### FAIRLIGHT BOARDING HOUSE

195-197 SYDNEY ROAD FAIRLIGHT NSW 2094

**S4.55 SUBMISSION**

:125, 1:1 @ A1	PROJECT NUMBER: 20025	
A	A03.01	В

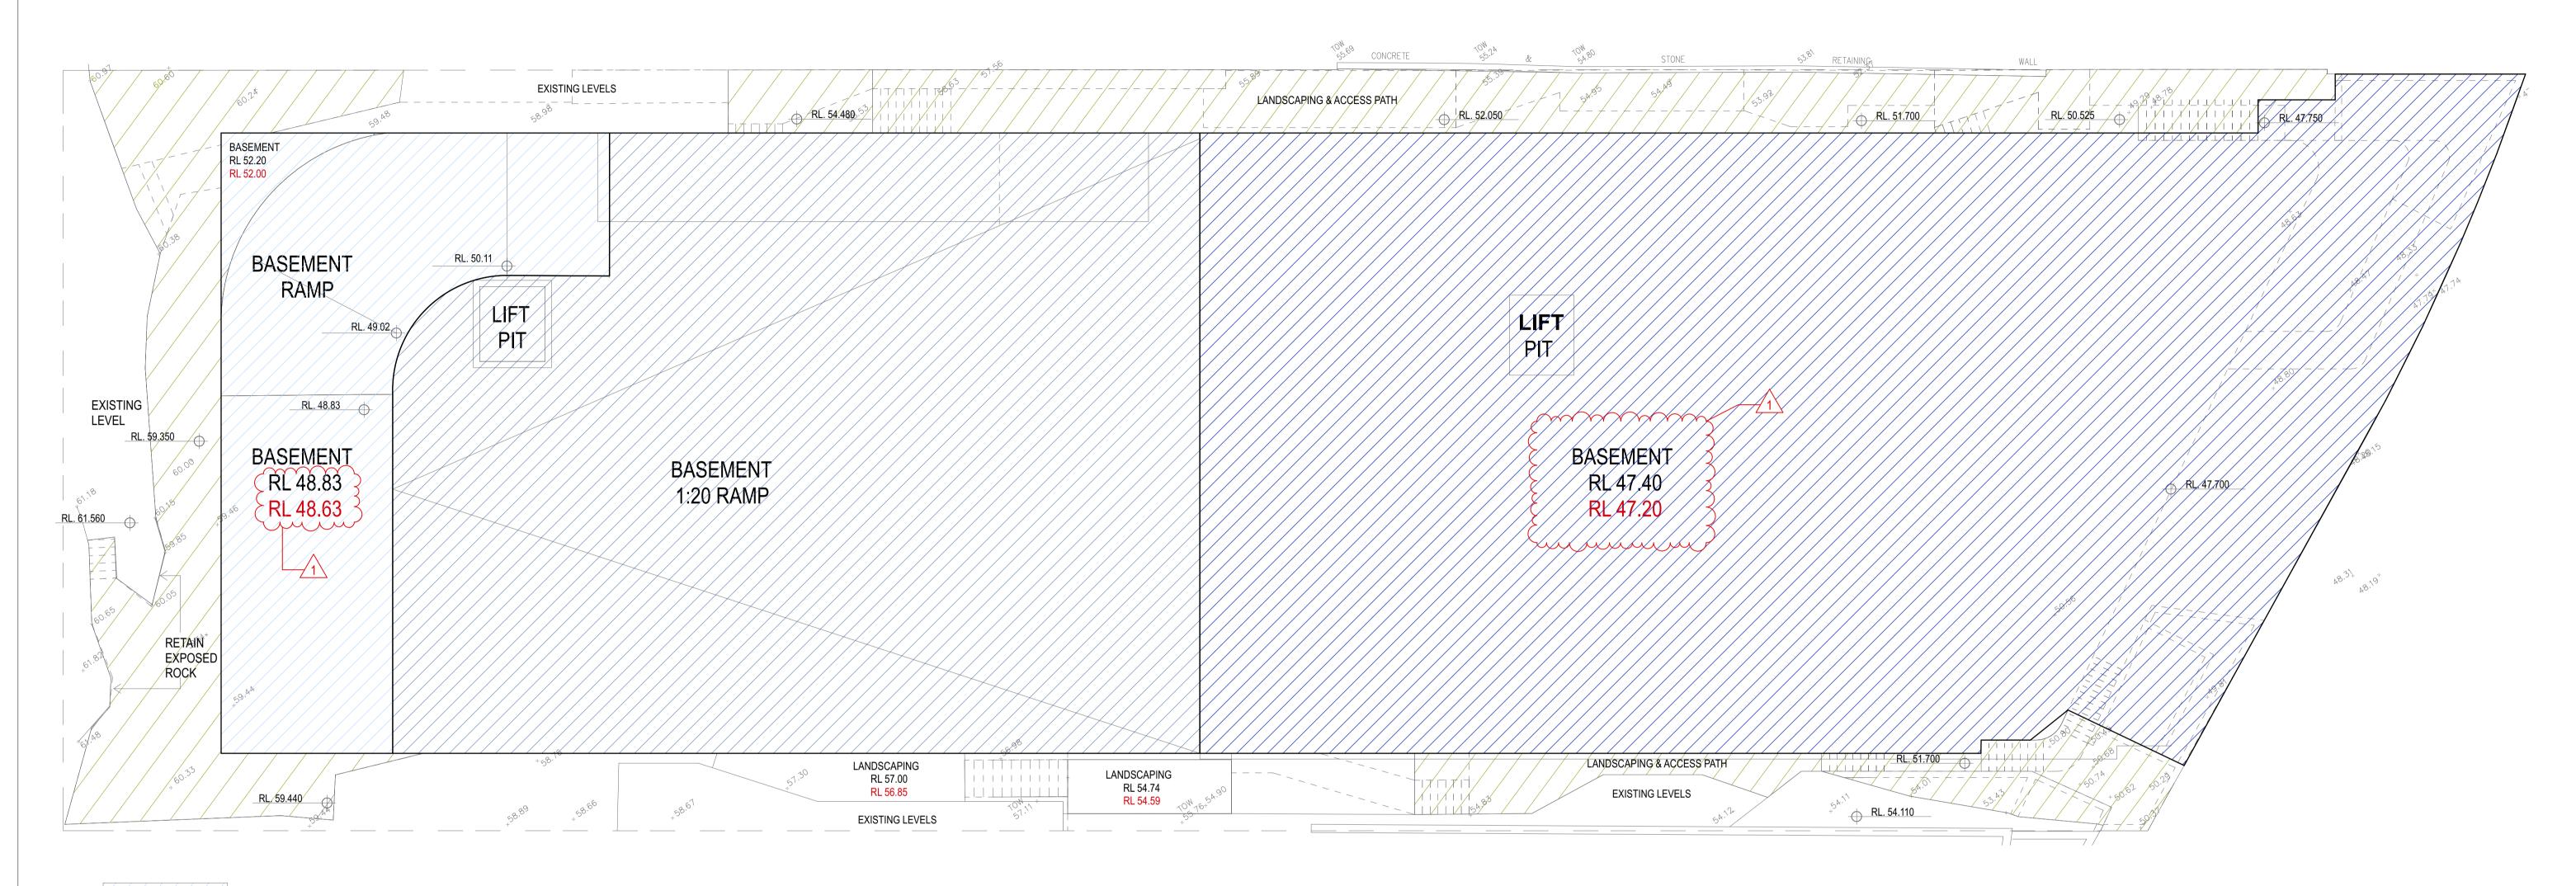
FIRE BOOSTER/HYDRANT, GAS METER & WATER METER CUPBOARD HEIGHT AMENDED FOR COMPLIANT.
 FINISHES No. 7 AMENDED FROM SCREEN BLOCKS TO GLASS BLOCKS FOR FRL 90 MINS COMPLIANT.
 CHANGE DOUBLE HINGED GARAGE FULL HEIGHT DOOR TO A ROLLER DOOR.
 RAISE WALL TO ACHIEVE 3500mm CLEARANCE TO TRUCK FOR ACCESS TO LEVEL 0.
 ADD GATE.

GROSS FLOOR AREA CALCULATIONS

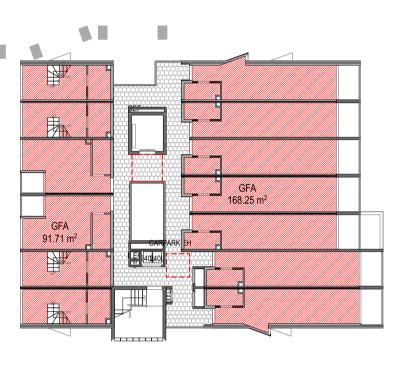
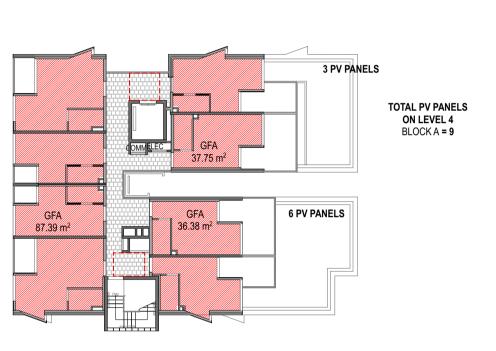
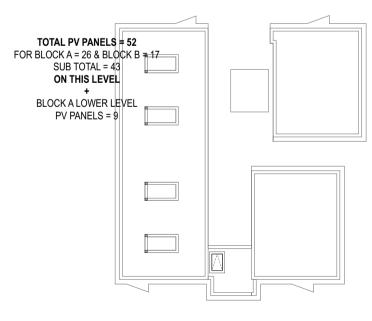
CLOUDED MODIFICATIONS:					
	1. GFA AMENDED.					
	DRAWN BY:	CHECKED BY:				
	MMO	AM				
	<b>▼</b> 100 mm ACTUAL <b>►</b>					
	IF THE ABOVE DIMENSION DOES NOT MEASURE ONE HUNDRED MILLIMETERS (100 mm) EXACTLY, THIS DRAWING WILL HAVE BEEN ENLARGED OR REDUCED, AFFECTING ALL LABELED SCALES.					
	SCALE:	PROJECT NUMBER:				
3	1:250 @ A1	20025
